A D D E N D U M N O . 5

ROOF REPLACEMENT AND RELATED WORK
WESTERN ELEMENTARY SCHOOL
Naugatuck, CT
KBA #15037.00

Date: February 12, 2016
Page: 1 of 2

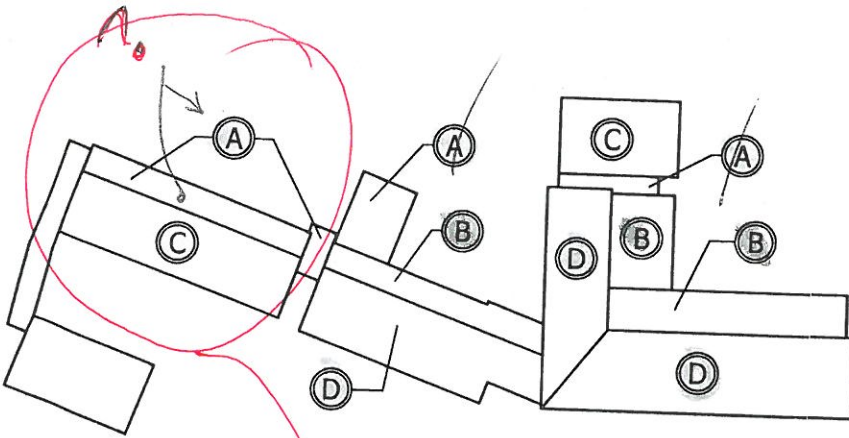
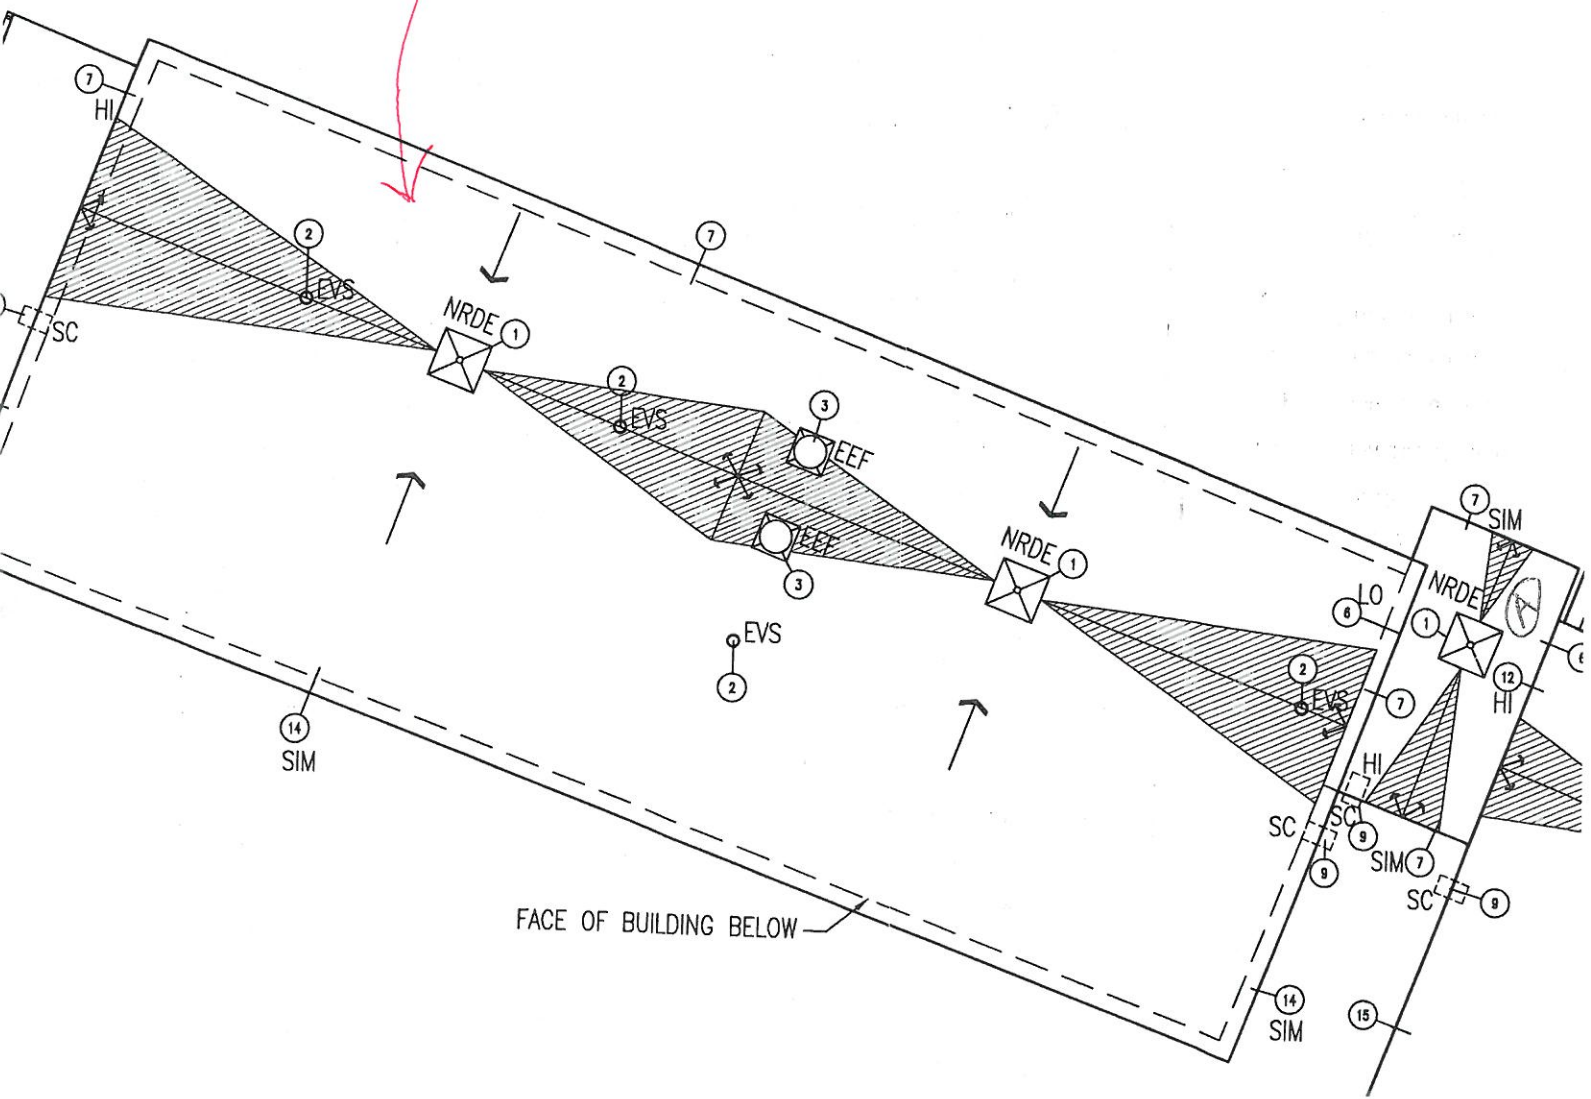
1. Is the Test Core information from 2nd site visit to be published?
2. At the chimney details #11+ #13 note reads "remove and replace damaged bricks"... How many bricks? Any chimney pointing? To make this work an equal playing field, Can this work be done off an allowance or can you quantify the amount of brick and or pointing to be included?
3. Please see attached partial roof plan. Is Roof Type 'A' an error? Should entire roof be Type 'C'?

DOESNT MATCH ?

- 1. Test cores done on second site visit were done individually by roofing companies. The results were not published.**
- 2. Remove and replace ten (10) bricks at chimney repair. No repointing to be done, except in area of repair.**
- 3. Roof Types in plan are correct. The difference is in the amount of roof insulation on each slope.**
